57 Main Street

Revised Site Plan
and Architectural Elevations

Materials

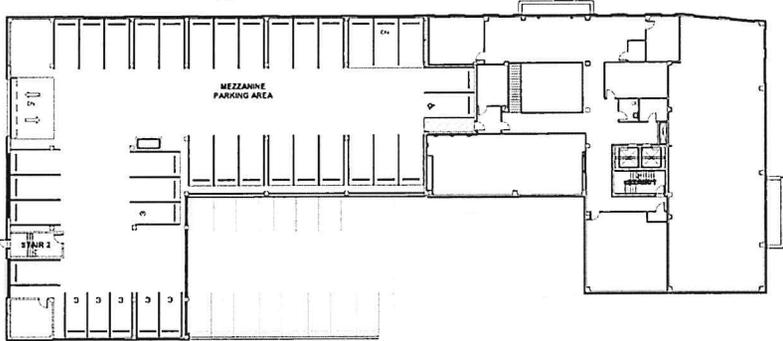
Predominant Materials shall be red brick, stone or precast materials where not adjacent to residential districts: The primary facades are now predominantly brick
Lap siding is used where adjacent to residential zones. Additional brick is added at the park

On-site Parking: Revised Design

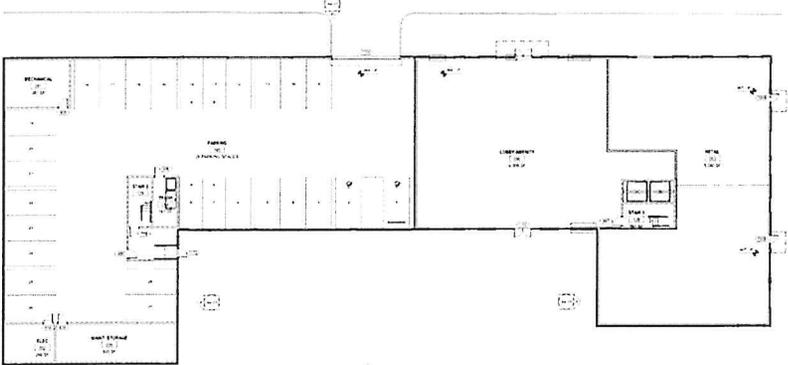
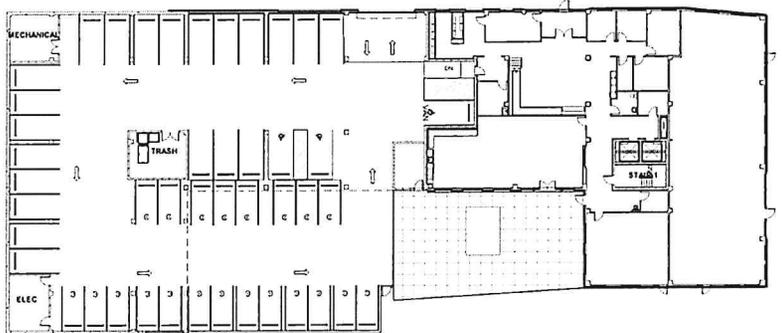
The On-Site parking count will be tripled from 28 to 82 spaces

The increased parking requires a reduction in outdoor common residential amenity space. While this is a difficult concession to make, the overall layout still includes some common outdoor space for residents

The retail area is reduced for 5,000 to 3,500 SF
